City of Portland, Maine – Building or Use Permit Application 389 Congress Street, 04101, Tel: (207) 874-8703, FAX: 874-8716

Location of Construction: 28 Milk St. Portland 04101		Owner: OceanBlock Assoc.		Phone: 774-1000		Permit No: 990556	
Owner Address: 42 Market St. Portland 04101		Lessee/Buyer's Name:		Phone:		BusinessName:	
Contractor Name: Monohan Woodworks		Address: 155 Falmouth St. Portland 04102		Phone: 775-2683		Permit Issued: JUN 3 1999	
Past Use: Retail		Proposed Use: Same		COST OF WORK: \$ 5,000.00		PERMIT FEE: \$ 45.00	
Proposed Project Description: Remove Existing Staircase Interior Renovations		FIRE DEPT. <input checked="" type="checkbox"/> Approved <input type="checkbox"/> Denied		INSPECTION: Use Group: TM Type: J13 00CA96		Signature: <i>[Signature]</i>	
		Signature: <i>[Signature]</i>		Signature: <i>[Signature]</i>		Date: <i>[Date]</i>	
Permit Taken By: U.B.		Date Applied For: GD May 27th, 1999		PEDESTRIAN ACTIVITIES DISTRICT (P.A.D.) Action: <input type="checkbox"/> Approved <input type="checkbox"/> Approved with Conditions <input type="checkbox"/> Denied		Zoning Approval: <i>[Signature]</i>

BUILDING PERMIT REPORT

REASON FOR PERMIT: Renaissance

1st Floor

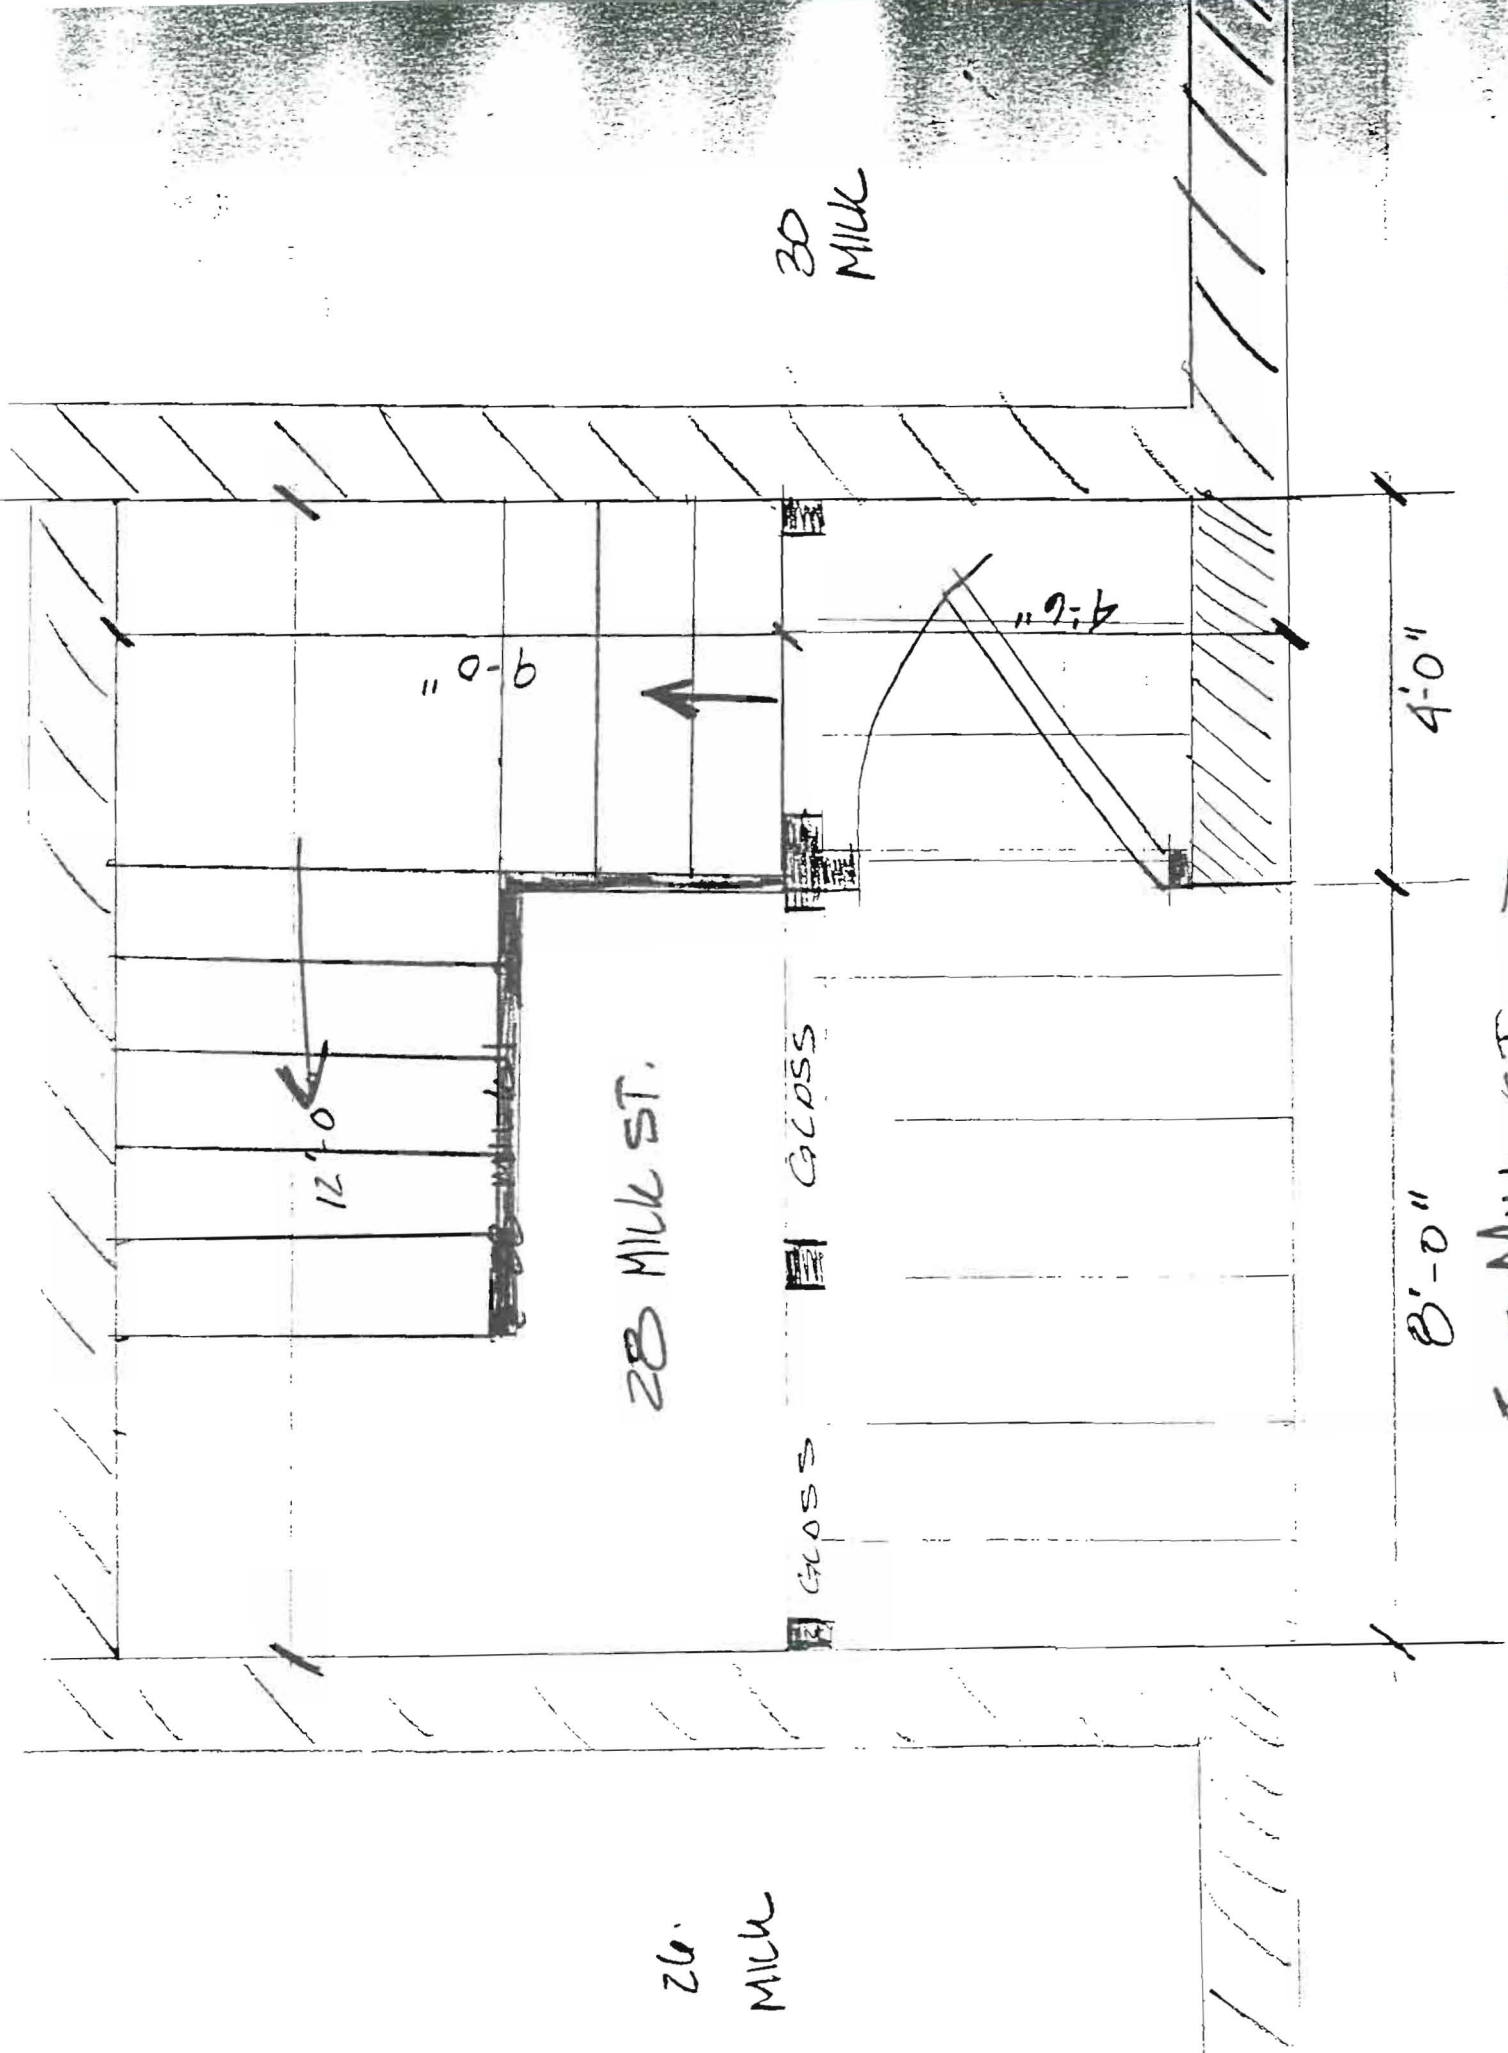
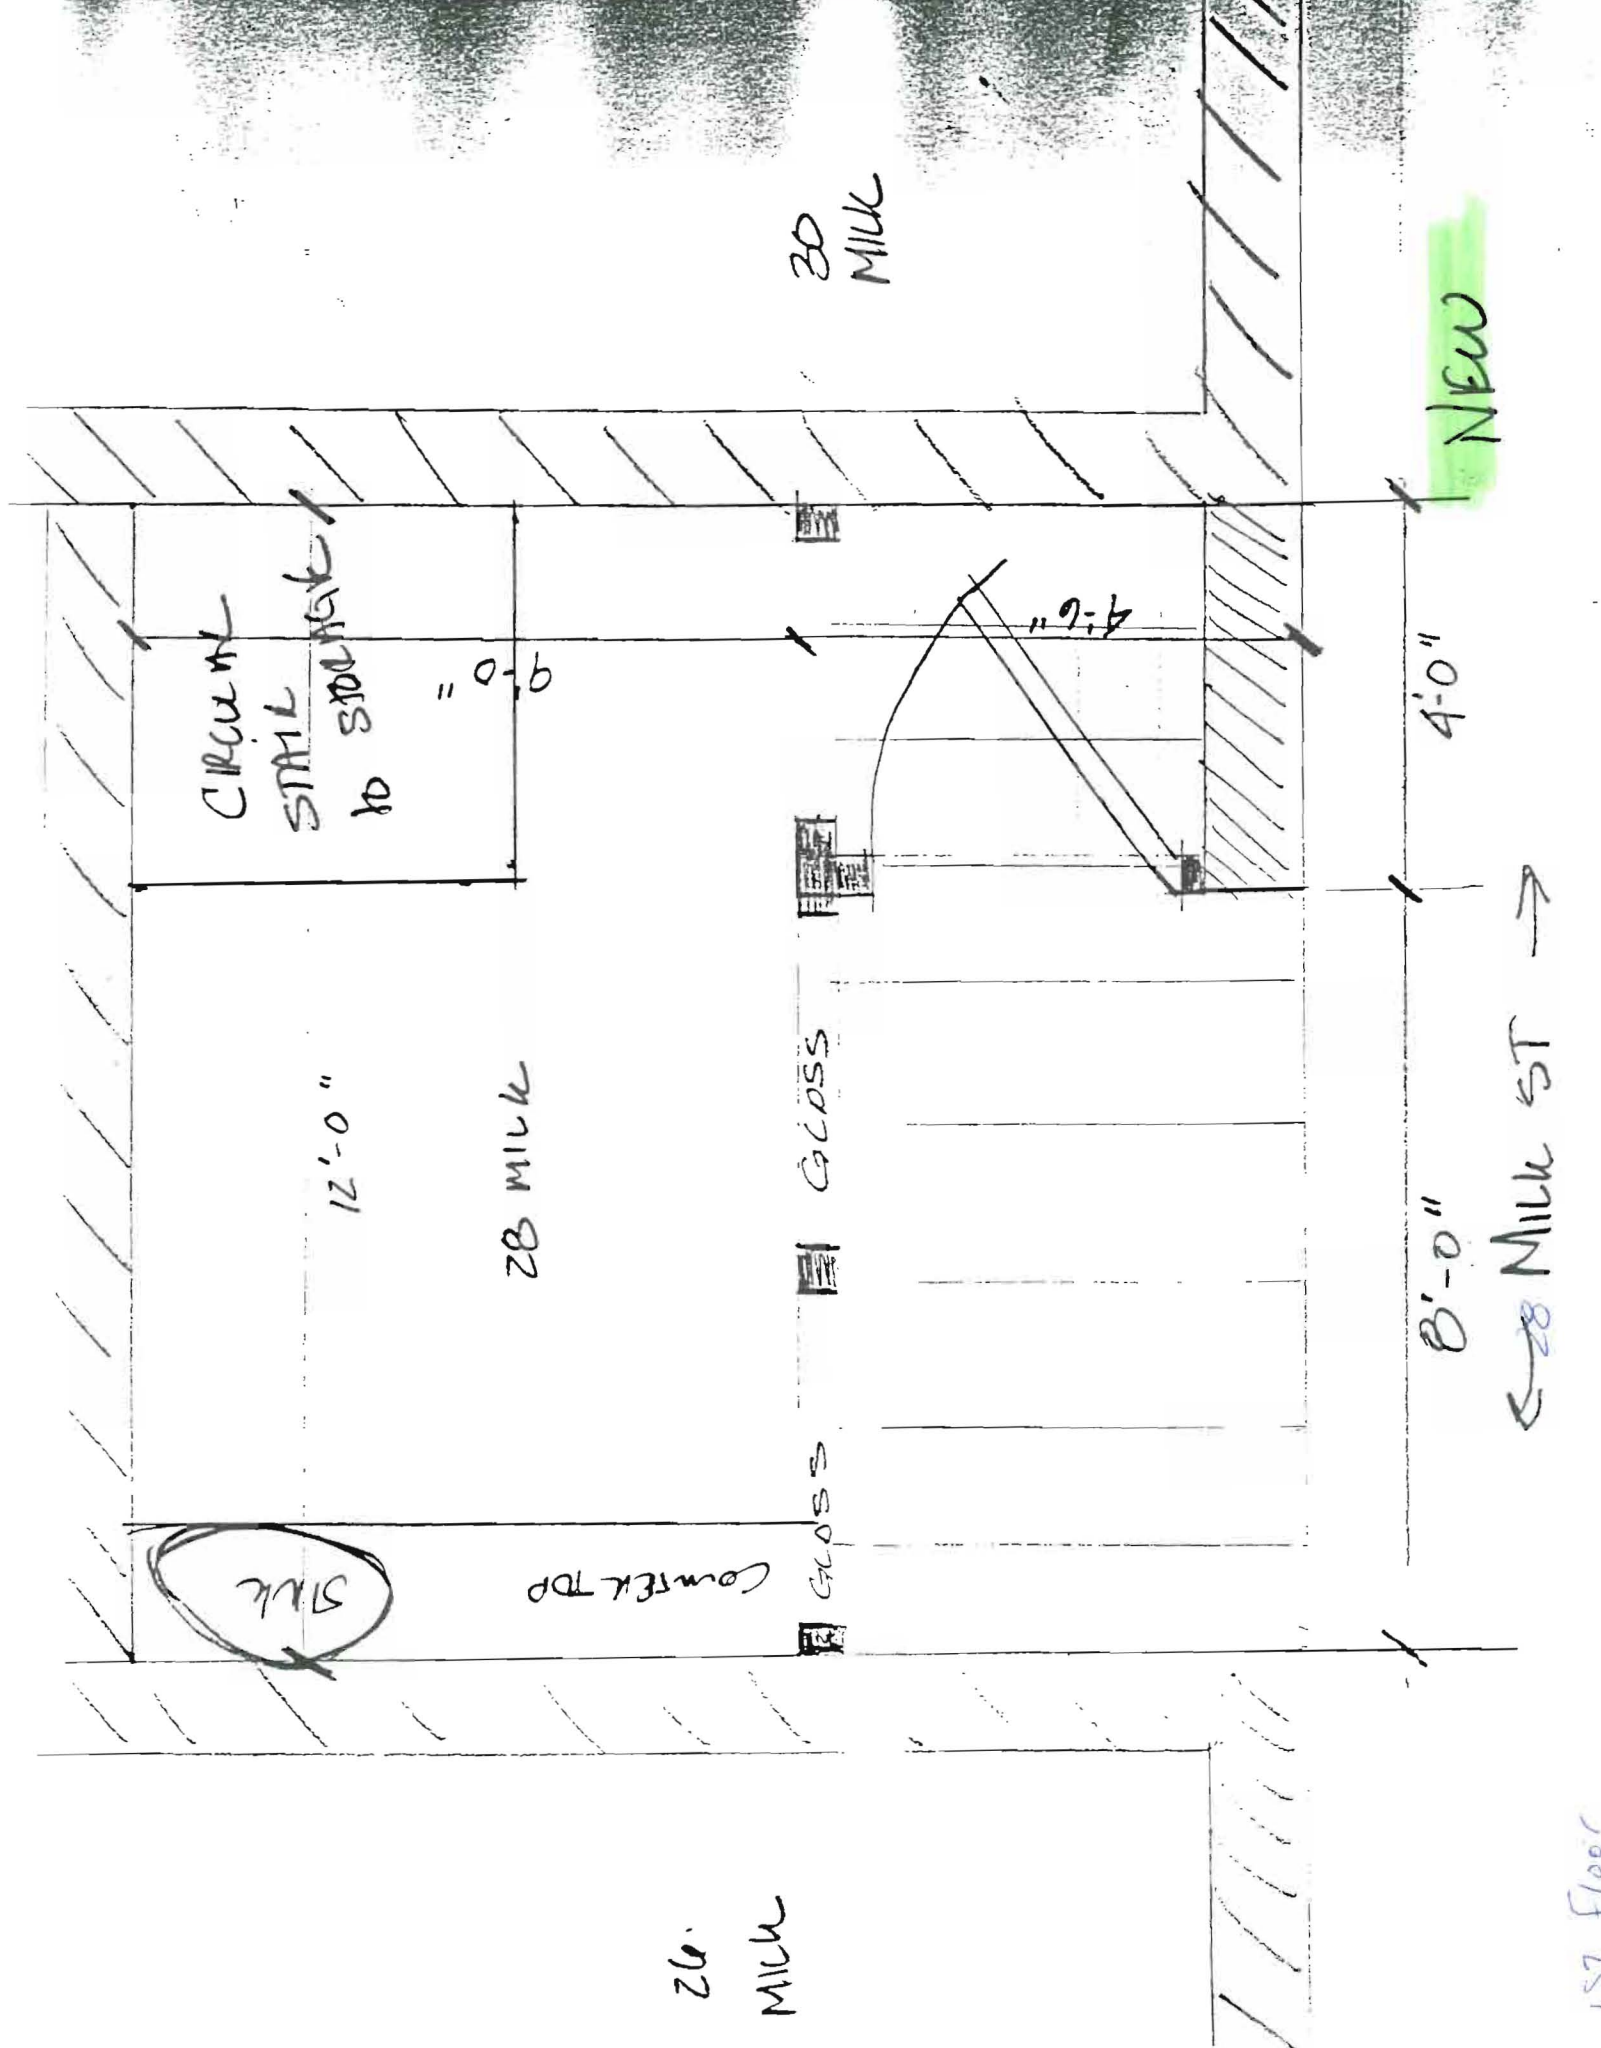
Approved with the following conditions: *1, *11, *13, *22, *23, *27, *29, *33

12. Headroom in habitable space is a minimum of 7'6". (Section 1204.0)
13. Stair construction in Use Group R-3 & R-4 is a minimum of 10" tread and 7 3/4" maximum rise. All other Use Group minimum 11" tread, 7" maximum rise. (Section 1014.0) Circular STAIR requirements: 1014.6.5 Bldg. Code
